CONSTRUCTION BULLETIN

Issued By: Julia Hoban, Red Architecture

Project: Walnut Hills – Store 4870 – CMG1144

Issued on: 05/09/2024 Regarding Construction Documents dated: 05/08/2024

E110

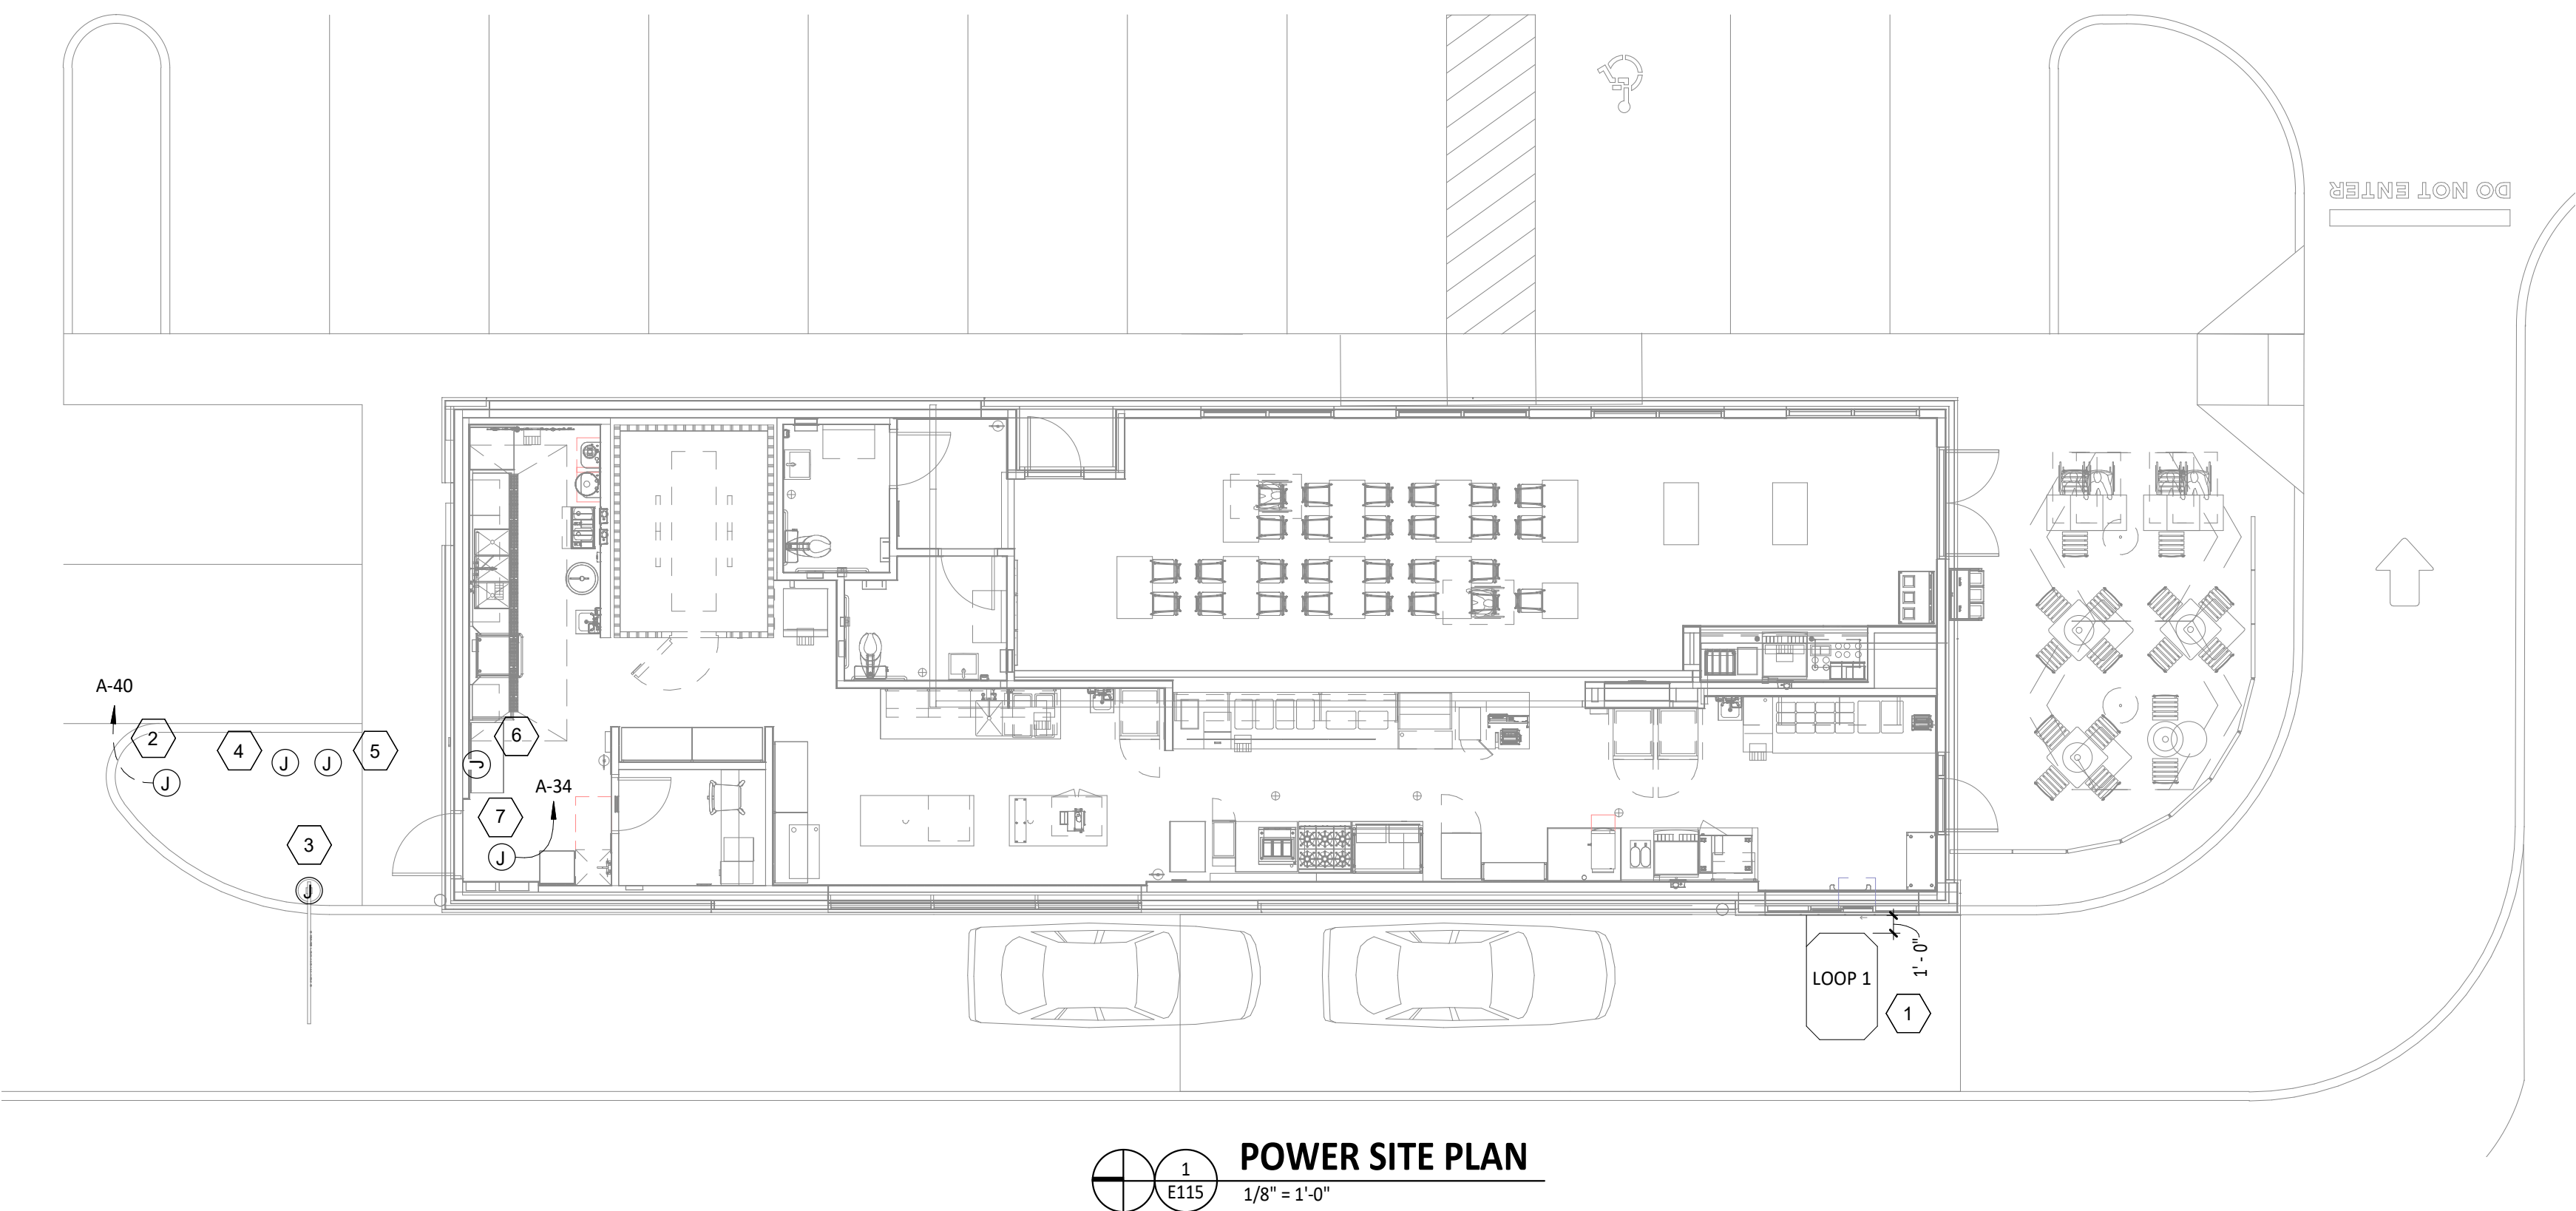
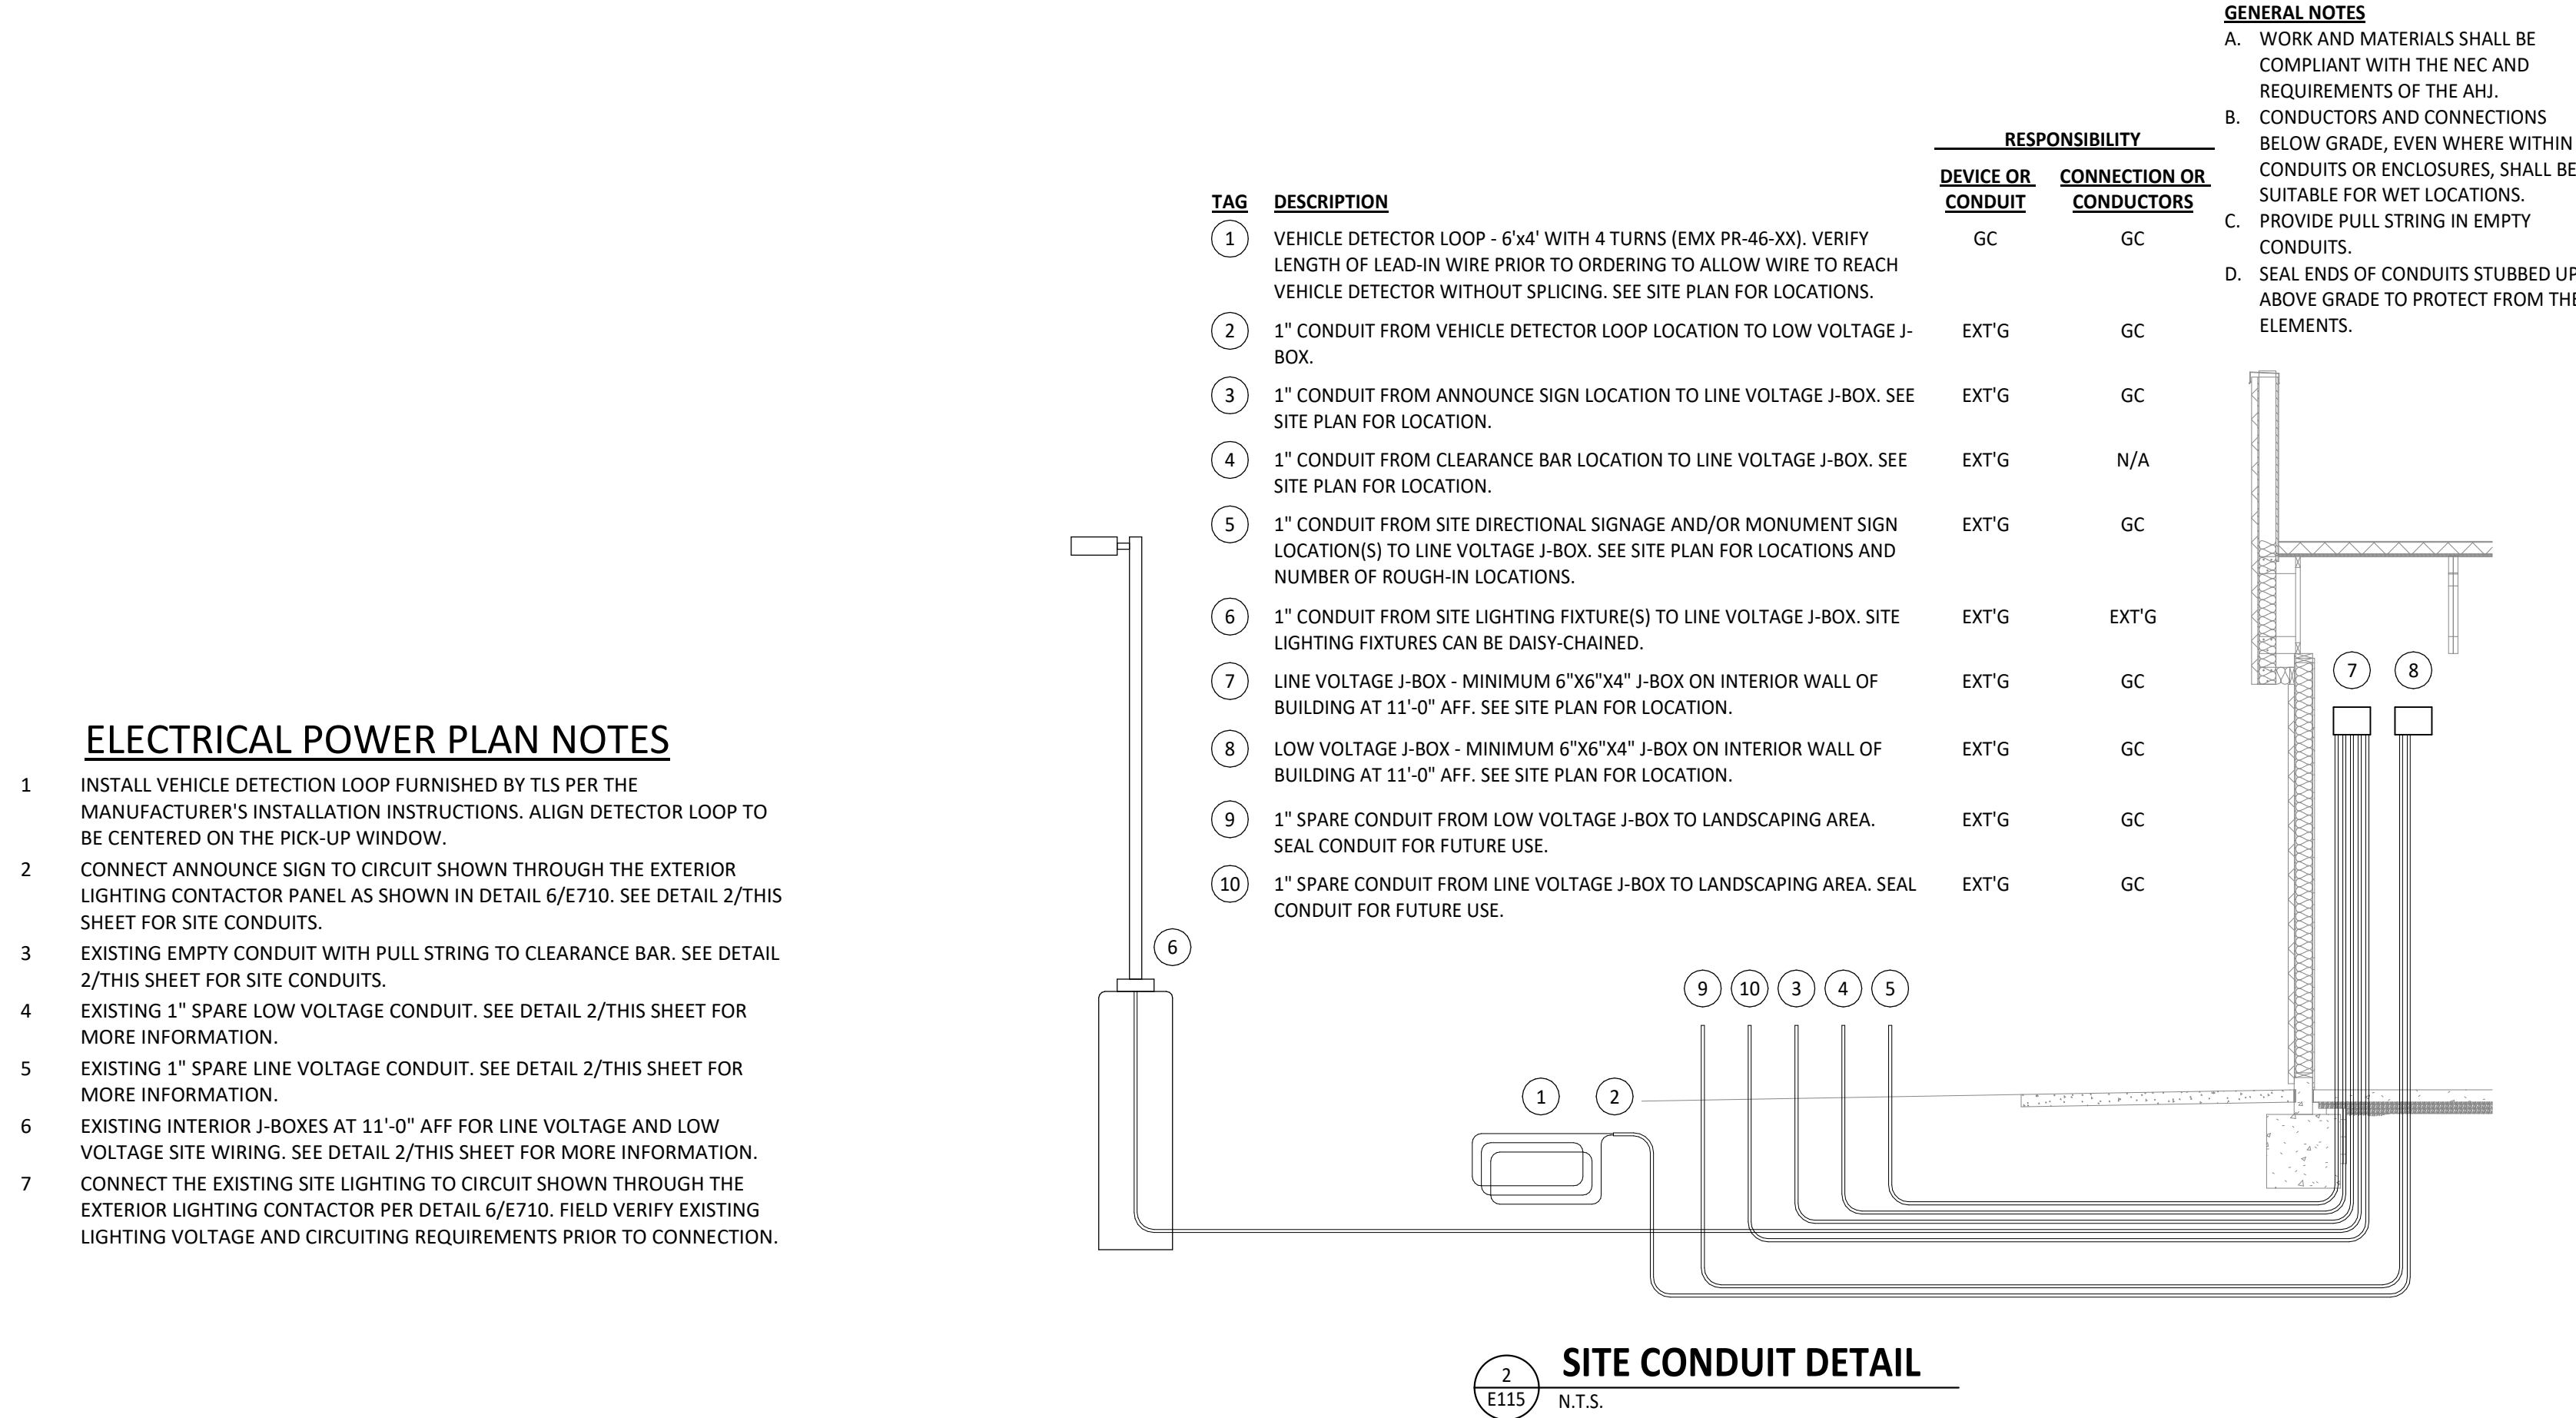
#1	Revision	X	Per Direction of: <i>permitting jurisdiction</i>
	Correction		
<i>The hand sink located in the prep area shifted to the other side of the prep sink per comments from the health department. The prep sink and associated floor sink below shifted slightly also to accommodate.</i>			
<i>The following sheets were revised and clouded as Revision 1: G000, G001, A101a, A130, A702, P100, P110, E110</i>

#2	Revision	X	Per Direction of: <i>permitting jurisdiction, owner</i>
	Correction		
<i>NL was redefined to mean Normal Power Egress Lighting. Light fixture P6 was added to the NL circuit.</i>			
<i>Conductor and conduit sizes were added to the main distribution diagram.</i>			
<i>RTUs were swapped from York units to Carrier, rooftop plan was adjusted.</i>			
<i>The following sheets were revised and clouded as Revision 2: G000, A140, M100, M600, P100, E010, E100, E110, E600, E710</i>
